05 August 2015

Our Ref: J27035 / J31314
Your Ref: Email received 07 August 2011

RE: ESKOM EIA CONCERNS FOR THE PROPOSED NUCLEAR POWER STATION AND ASSOCIATED INFRASTRUCTURE (DEA Ref. No: 12/12/20/944)

Figure 1: The Historic Crossover – Solar photovoltaic costs are falling as new nuclear costs are rising.¹

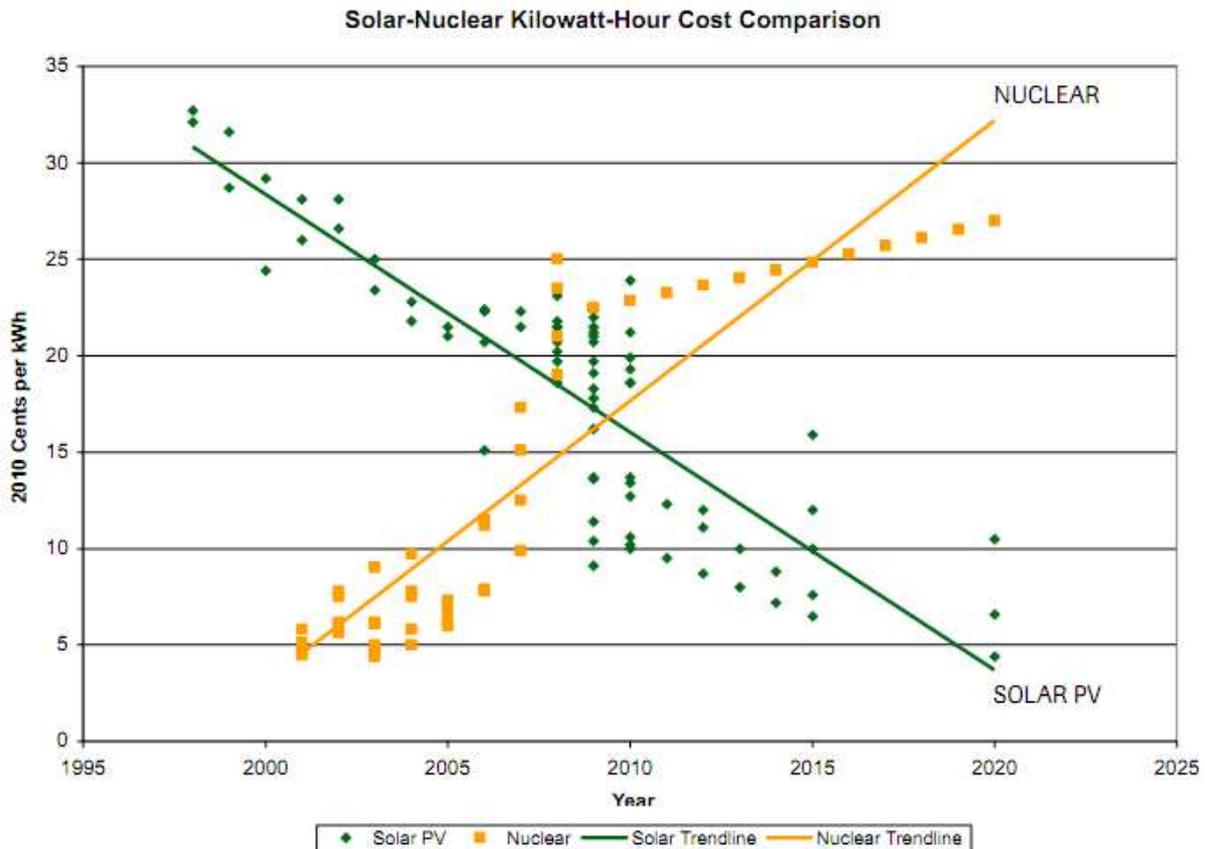
The cost estimates of photovoltaic systems used in the EIR is out by orders of magnitude. The given price per watt for a 125 MW solar farm is 5 to 10 times the hardware store retail prices of domestic portable 100 watt panels. See www.solarbuzz.com for photovoltaic costs. They provide a consulting service and they should be able to provide pricing data for large systems based on real world experience and independent analysis of price trends.

In a "historic crossover," the costs of solar photovoltaic systems cheaper a cheaper option than Nuclear power in 2010.

All the alternative technologies mentioned in Section 4.5.2 of the Economic Impact Assessment (Appendix E17 of the Revised Draft EIR Version 1) are based on reference EPRI report¹, which was commissioned for the Integrated Resource Plan IRP). The specific technology referred to is parabolic trough with a central receiver. Please refer to the EPRI report, which available on the IRP website, in this regard.

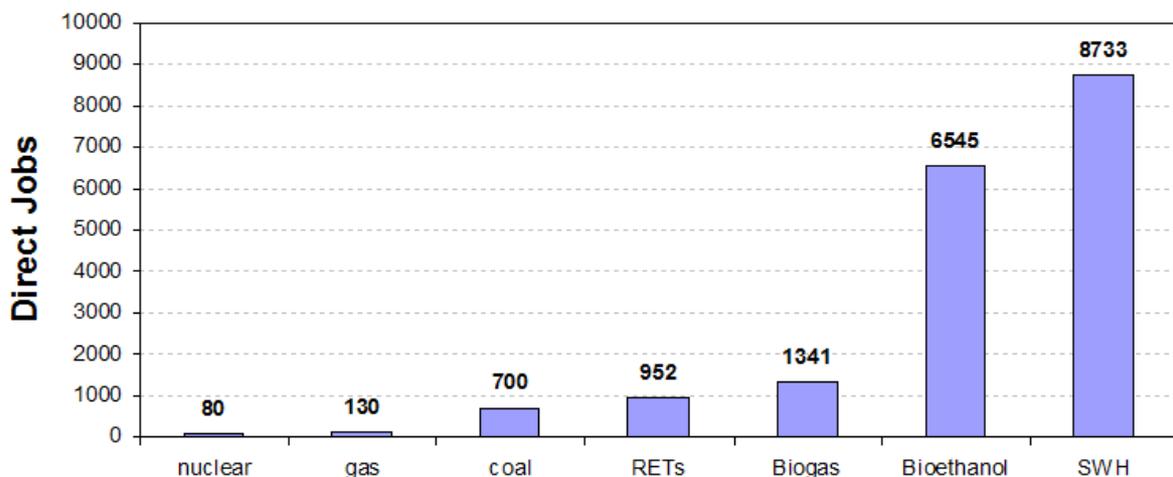
If wind turbines are distributed throughout this area the variability of the combined total wind power output will be much less than if fewer wind turbines are concentrated in a few places. More importantly the output and the variability in the output can be estimated and predicted with statistically determinable accuracy.

Scenarios like what happened in Spain in September 2010 can be effectively designed out.
